**PHOTOGRAPH #9**

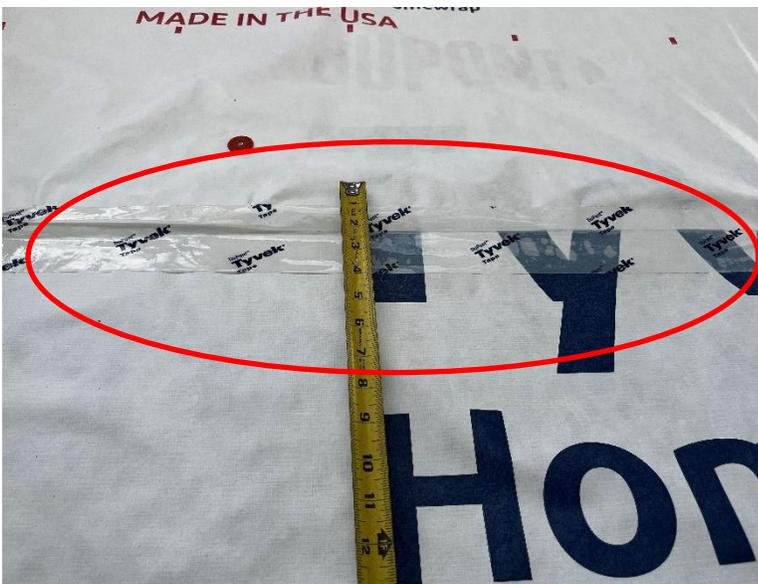
Contractor has covered new sheathing with Tyvek HomeWrap water resistant barrier.
